REVISED RESPONSE TO REQUEST FOR ADDITIONAL INFORMATION

APR1400 Design Certification

RAI No.: 208-8245

Question No. 03.08.03-5

Figure 3. GTSTRUDL Analysis Model 1

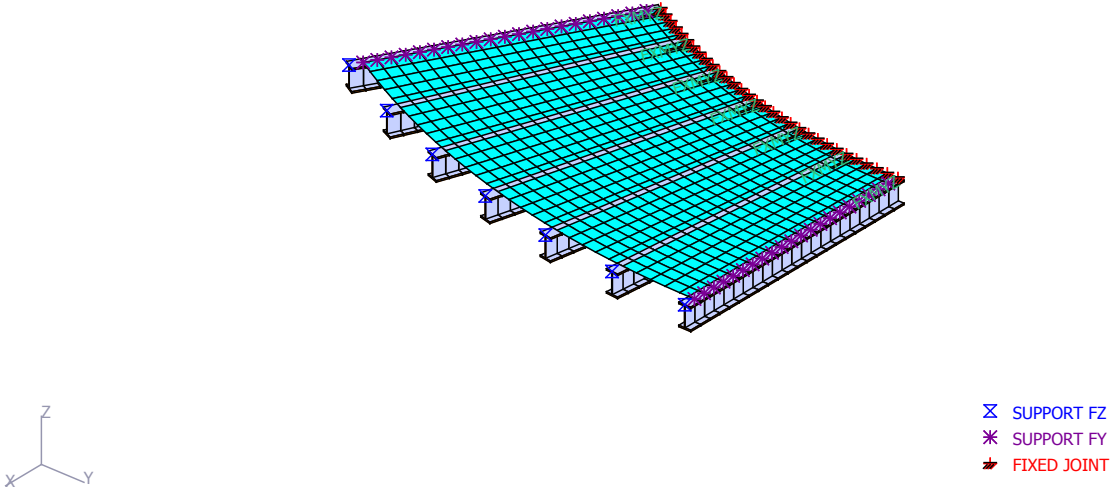
- a. APR1400 DCD Tier 2, Section 3.8A.1.4.3.1.3 describes the analysis methods and results for the containment internal concrete structures. It states that, "Operating concrete floor slabs are modeled to mass in a finite element model (FEM), such as slabs between the SSWs and containment shell." Per 10 CFR 50.55a; Appendix A to 10 CFR Part 50, General Design Criteria 1, 2, 4, 16 and 50; and SRP 3.8.3, the applicant is requested to clarify if this meant to say that the operating floor slabs between the secondary shield walls (SSWs) and the containment shell are included as masses in the FEM. If this is the case, then explain why it is acceptable to decouple these slabs from the overall FEM analysis of the internal structures and how is the analysis and design for such subelements performed for all of the various loadings.

There are various analysis models for the local slabs depending on the elevation and thickness. Among them, the representative model which is a 3-ft thick operating floor slab at EL.156'-0" is as follows;

The structural analysis model for the slab at EL. 156'-0" consists of:

The supports at the secondary shield wall side are considered to be fixed - on the other hand, those at the containment wall side are considered as support for the vertical translation. Both sides of slab are developed as y-direction restraint joints since 3 ft slab and 2 ft SIT lateral support slab are located next to 3 ft slab at each side.

Model 1 - one edge fixed, the other edge hinge (Figure. 3)
